2013 OBD/GHG14, 6-Gallon DEF Header Suction Line Connection Broken by Ice Pressure

49-16

Western Star
Service Bulletin

SB-10058360-5473

Fig. 2, WEMA Six Gallon DEF Tank Header Assembly

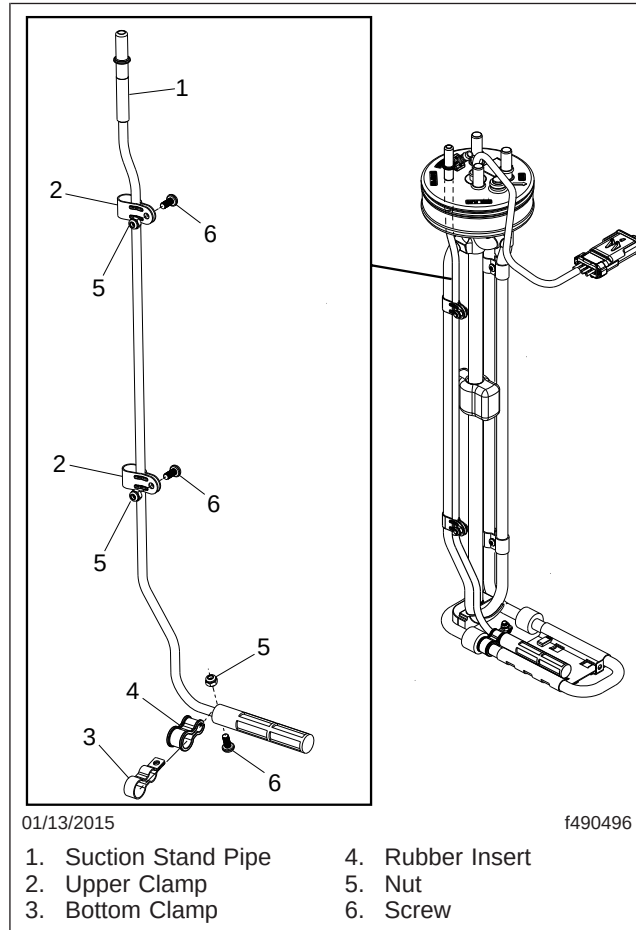
Replacing the suction stand pipe involves removing the header from the tank, disassembling the header and reassembling it with the new suction stand pipe that has smaller diameter and a larger fitting. With the larger fitting on the stand pipe, a different DEF line is required to connect to it.

9. Remove the header from the DEF tank.
 10. If desired, rinse the header unit with hot water before working on it.
 11. Replace the DEF suction stand pipe.
 - 11.1 Remove the clamps that attach the suction stand pipe to the coolant pipe. (These may be clamps with screws and nuts, springs wound around the pipes, or zip ties.)
 - 11.2 Remove the rubber insert from the bottom clamp if applicable.
- NOTE: It takes about 9 kg of pulling force to remove the suction stand pipe from the rubber head.
- 11.3 Slide the suction stand pipe out from the bottom of the rubber head.

- 11.4 Install the new suction stand pipe into the rubber head from the bottom. Make sure it is properly positioned.
- 11.5 Install the new bottom clamp with the rubber insert directly behind the filter.
- 11.6 Install the new clamps at the two upper locations as shown in [Fig. 2](#).
- 11.7 Tighten the clamp fasteners 25 to 29 lbf·in (280 to 360 N·cm).
- 11.8 Verify that the stand pipe sticks out of the top of the head enough to connect the DEF line fitting.
- 11.9 Verify that the DEF level float can travel freely for the entire length of the sensor tube.

12. Install the header unit in the tank and secure it with the band clamp.
13. If the DEF tank was removed, position the tank on the frame rail bracket, and install the two DEF tank mounting bolts and nuts. Tighten 128 lbf·ft (174 N·m).
14. Remove the DEF suction line and install the new one.
15. Connect the DEF lines.
16. Connect the coolant lines.
17. Install zip ties as needed to hold the chassis electrical harness to blue DEF lines on side of tank.
18. Remove the line clamps.
19. Connect the harness connector to the DEF sensor.
20. Connect the battery cables.
21. Start the engine and check for leaks. Repair as needed.
22. Put a dot of white paint on the connector to indicate the retrofit has been done.
